## **DIVISION II. RESIDENTIAL CODE**

**Sec 5-46. International Residential Code – Adopted.** The International Residential Code, 2015 Edition and Appendices G, H and J as published by the International Code Council, Inc., a copy of which is on file in the office of the City Secretary, as amended by Sec.5-47, administered and enforced by the office of the building official is hereby adopted by reference and designated as the Residential Code of the City as though such code were copied at length in this article.

**Sec 5-47. Same – Deletions and Amendments.** The following sections, paragraphs, and sentences of the *International Residential Code, 2015 Edition and Appendices* are hereby amended as follows:

(23) *Figure R602.6.1; delete the figure and insert the following figure:*

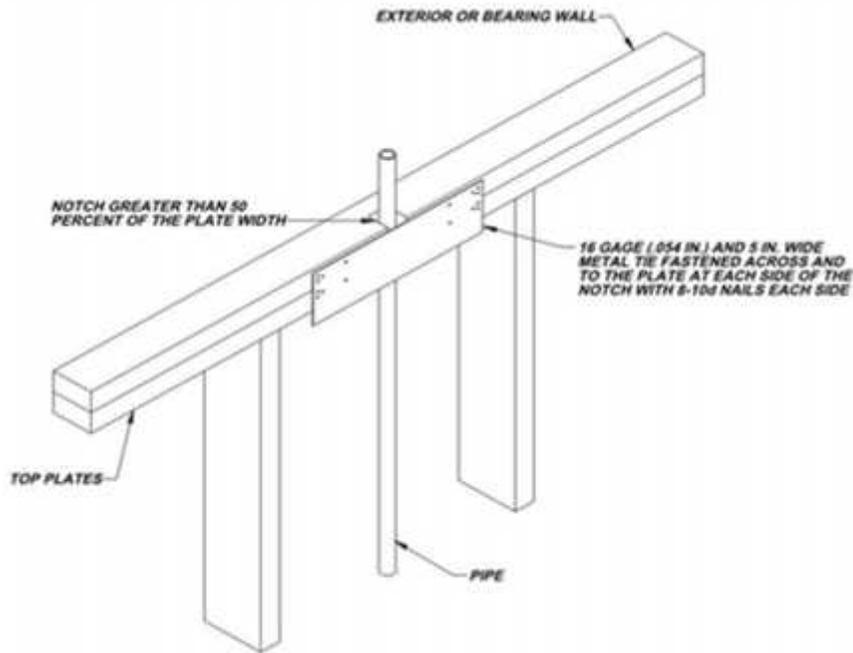
**R602.6.1 Drilling and notching of top plate.** When piping or ductwork is placed in or partly in an exterior wall or interior load-bearing wall, necessitating cutting, drilling or notching of the top plate by more than 50 percent of its width, a galvanized metal tie not less than 0.054 inch thick (1.37 mm) (16 Ga) and 5 inches (127 mm) wide shall be fastened across and to the plate at each side of the opening with not less than eight 10d (0.148 inch diameter) nails having a minimum length of 1 ½ inches (38 mm) at each side or equivalent. Fasteners will be offset to prevent splitting of the top plate material. The metal tie must extend a minimum of 6 inches past the opening. See figure R602.6.1. {remainder unchanged}
